AGENDA

Village of Chenequa Plan Commission
Monday, December 9, 2024 at 6:00 p.m.
31275 W. County Road K, Chenequa, WI 53029

STAFF REVIEW

Project Description: Proposed Single-family Dwelling and Landscape Plan

SCALE: 1/4" = 1'0"

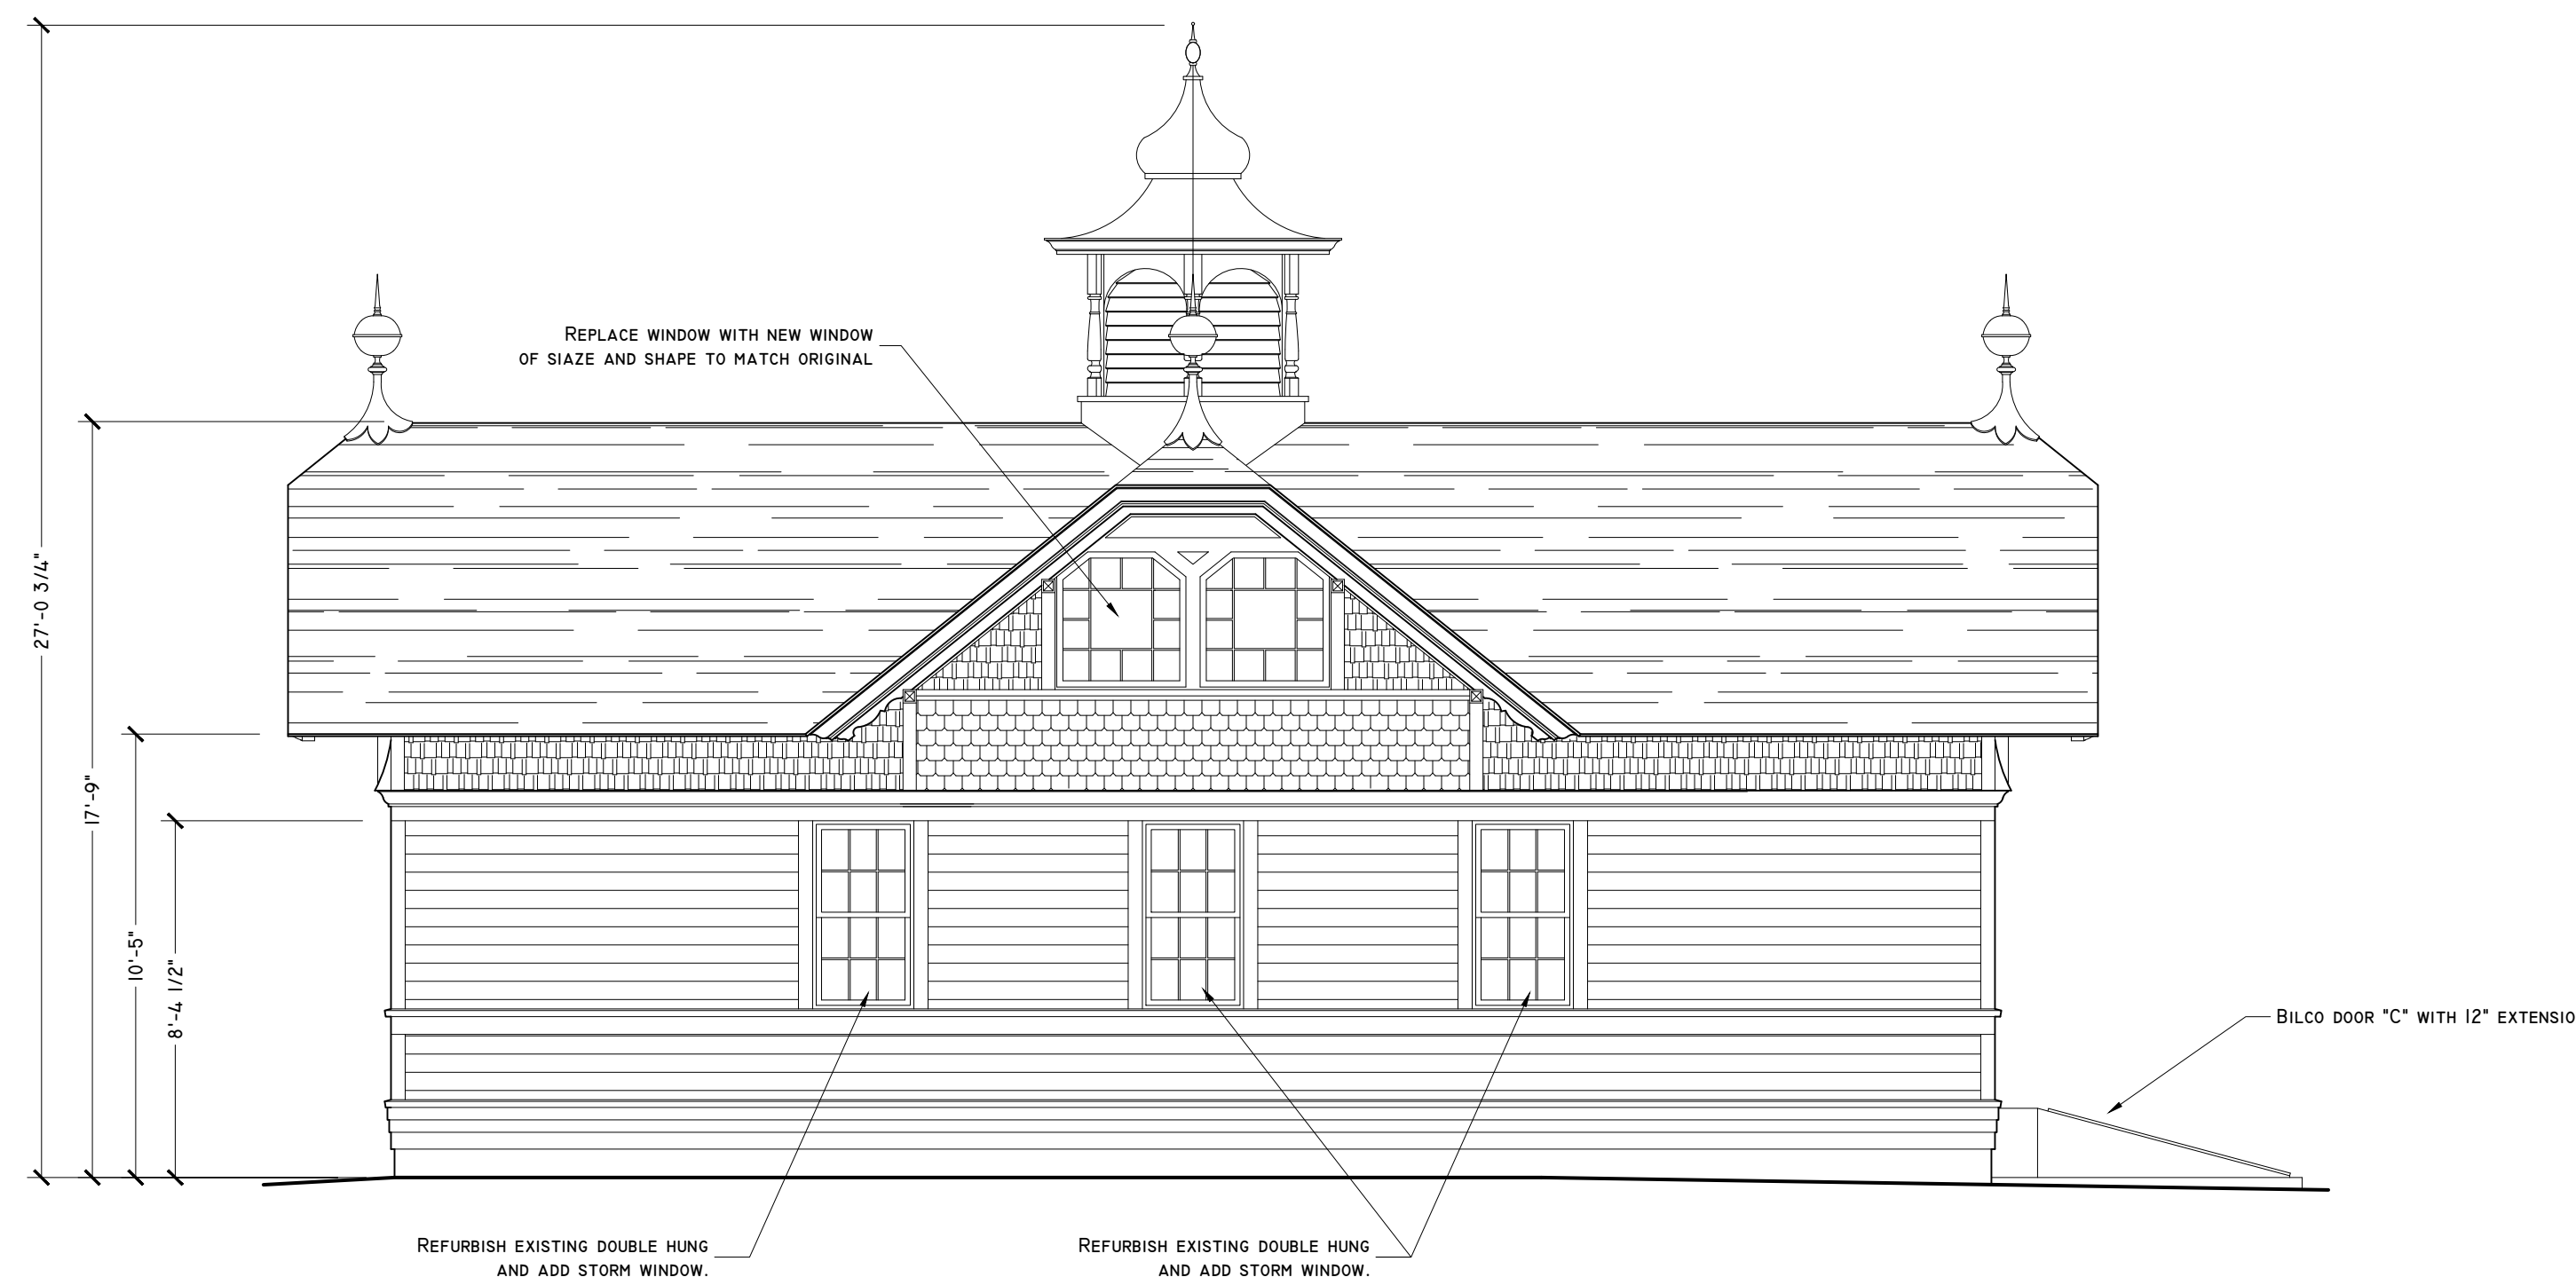
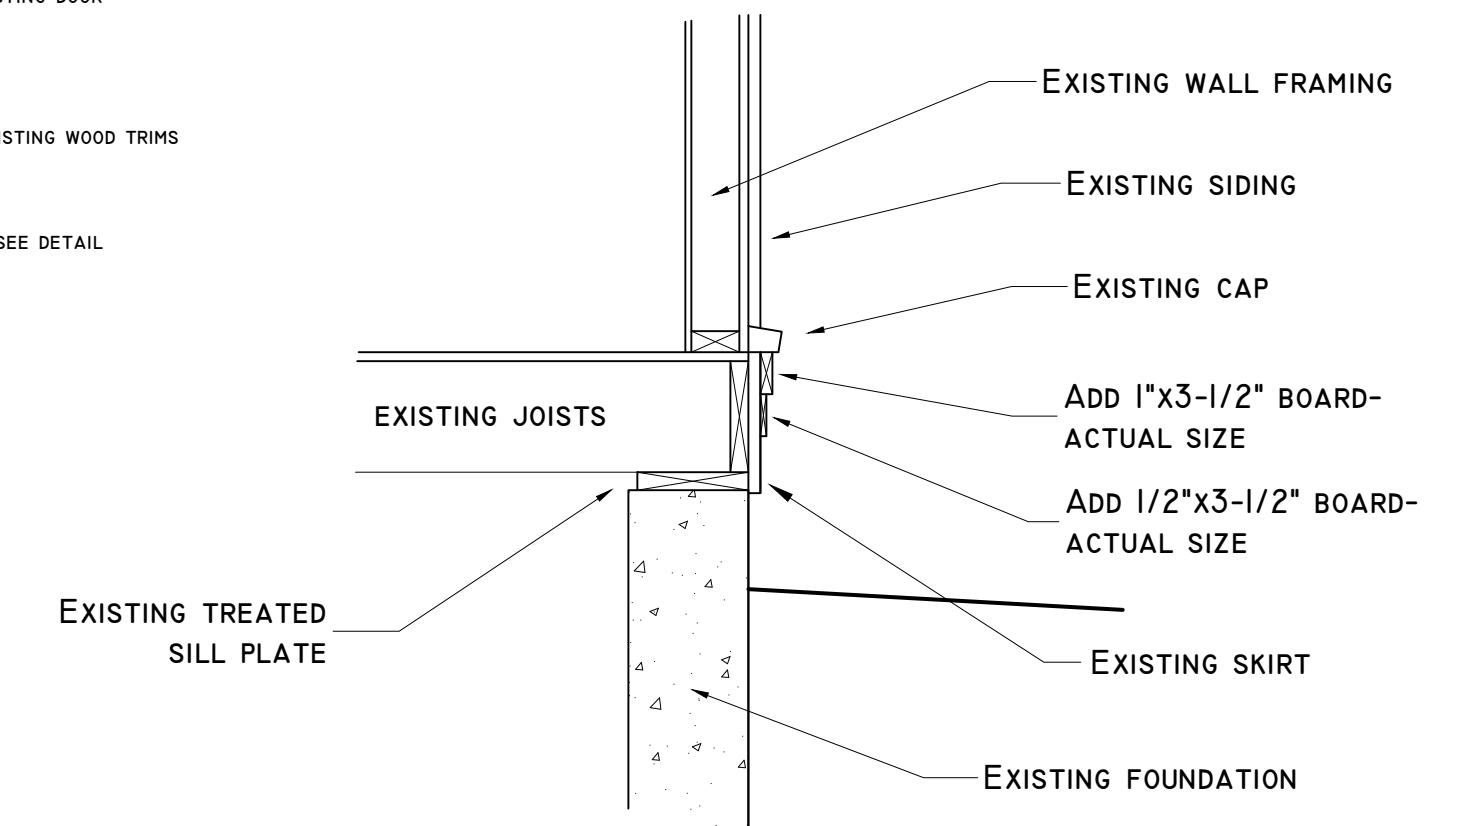
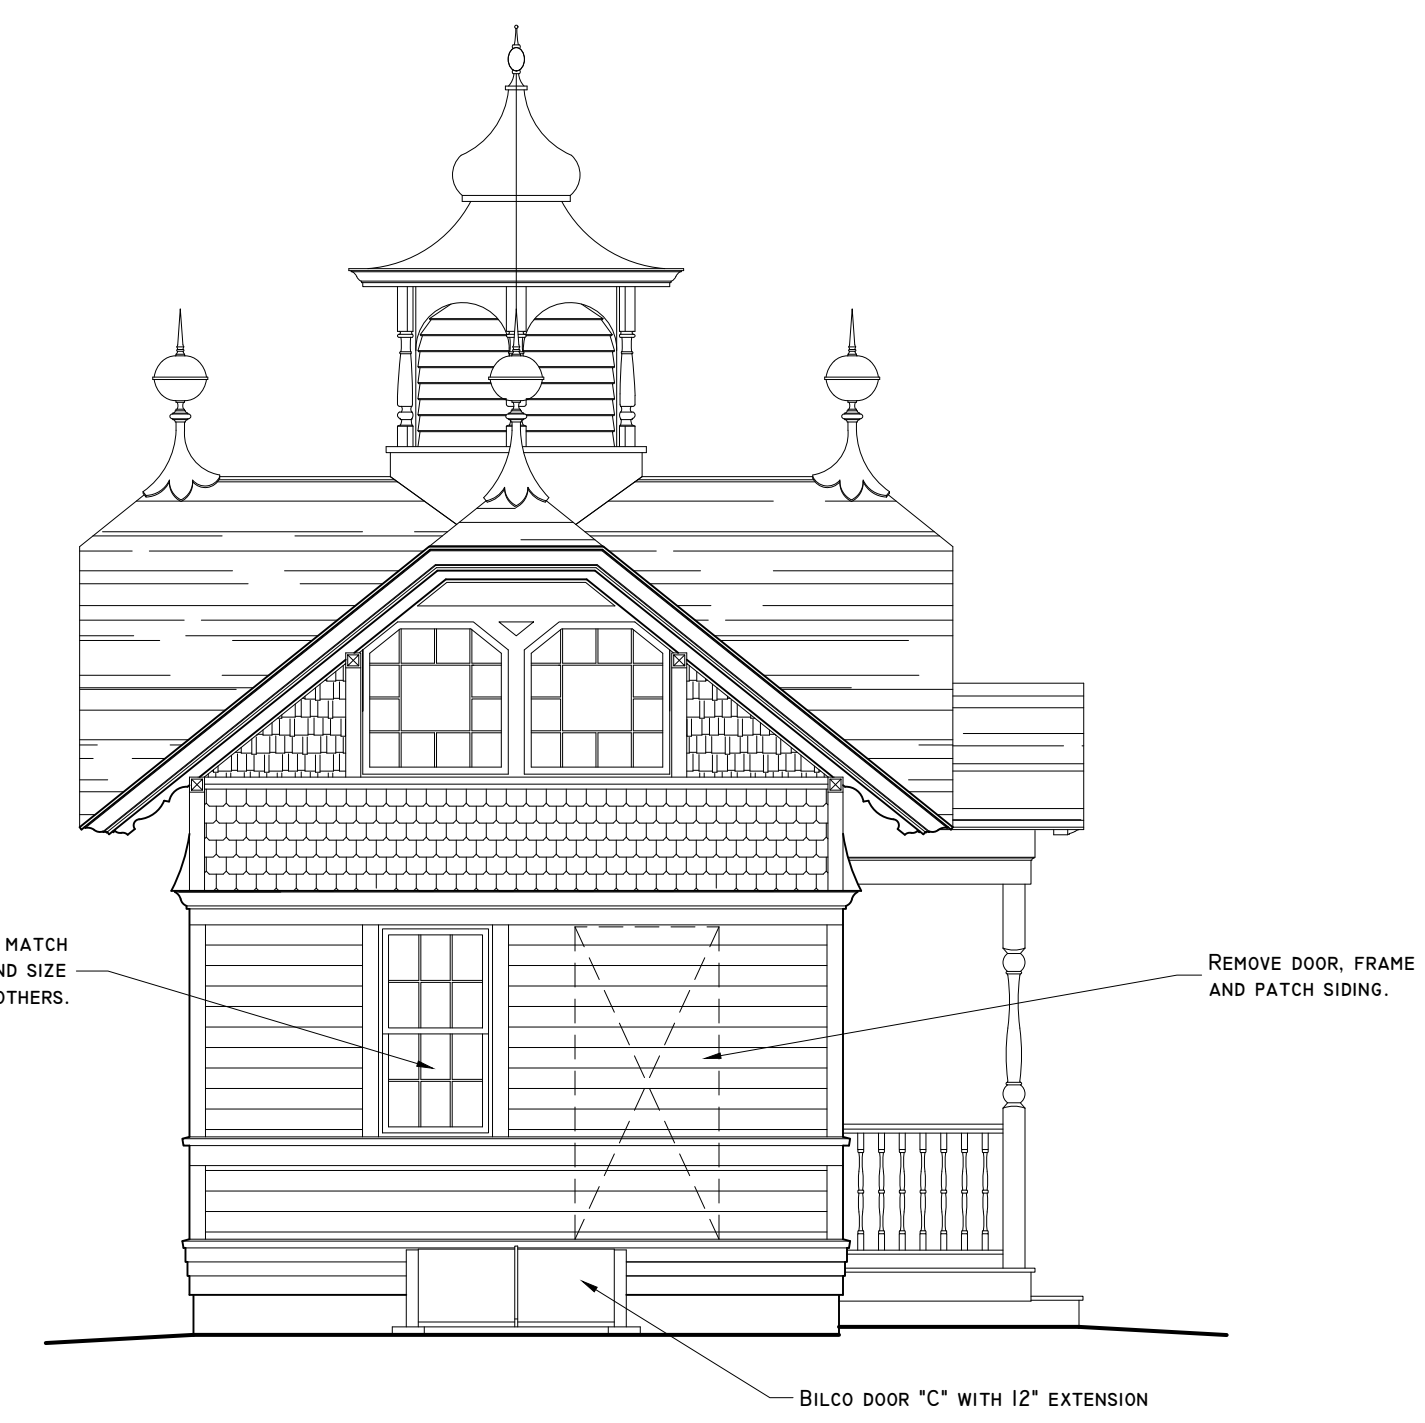
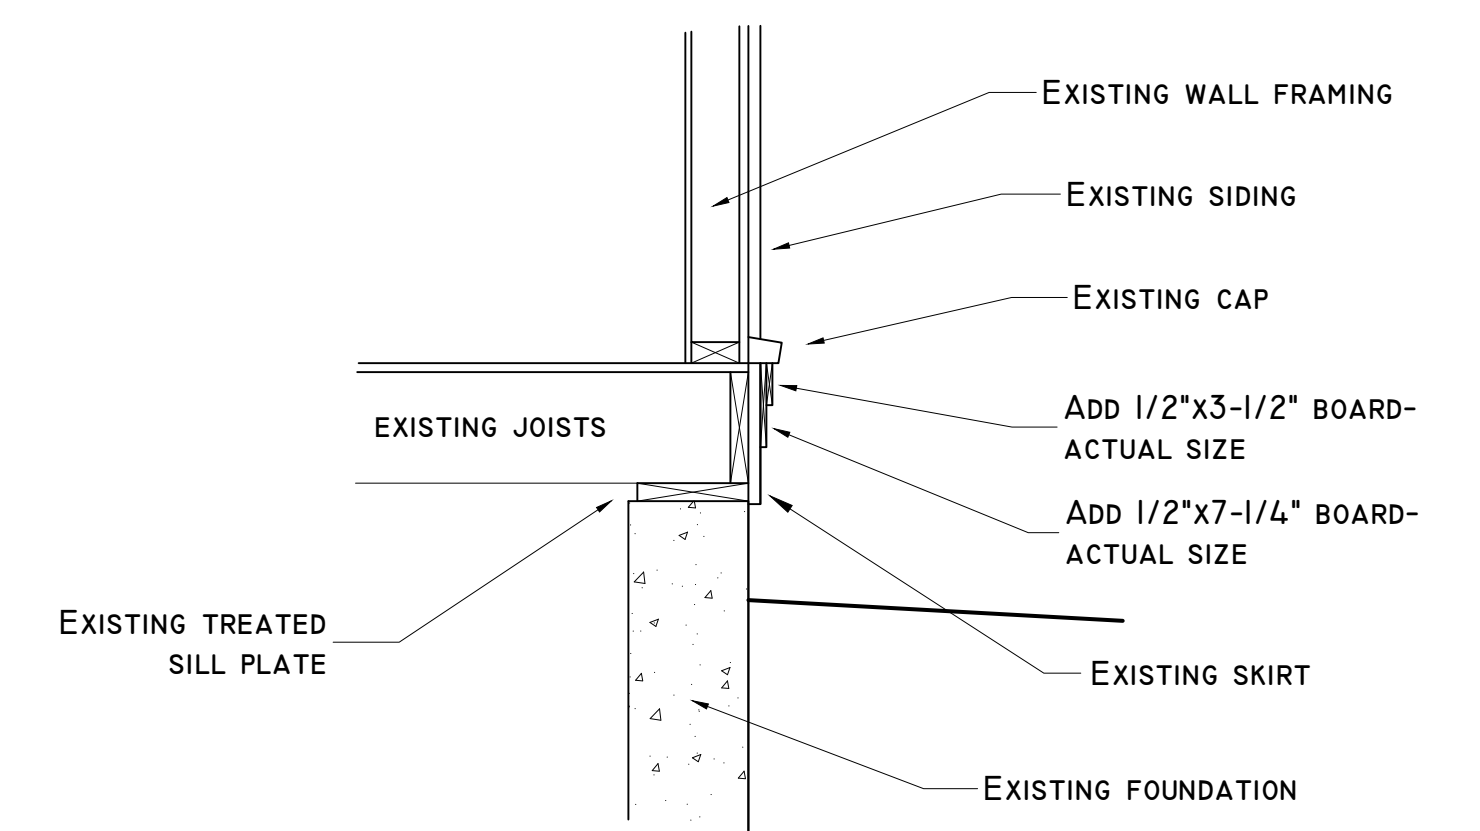
5. Existing and proposed elevations have been provided in your packet.
6. Exterior modifications include;
 - a. Repositioning doors and windows on the structure (as shown on plans)

- b. Installation of several new windows on the structure
 - c. Adding a small gable over the entryway (to match roof pitch)
 - d. Installation of bilco door to provide basement access

- e. Restoration of existing trim and siding
7. The existing color of this structure is white, this color is not proposed to change.
8. There is no exterior lighting proposed on this structure

Outdoor Lighting Cut List for:

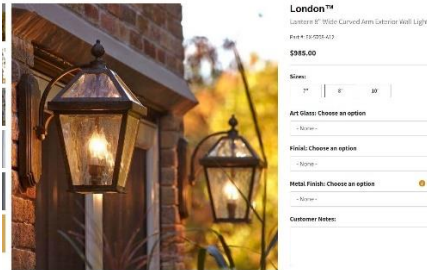
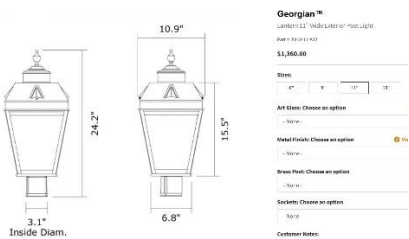
11. The provided plans also present an outdoor lighting plan. The lighting plan includes cut sheets of the proposed light fixtures to be used
 - a. The plan includes;

- i. 8 – Pathway Lights
 - ii. 1- Parking Light -**Not Compliant with 5.24**
 - iii. 1-“Bilco” door light
 - iv. 2- Entryway Lights -**Not Compliant with 5.24**
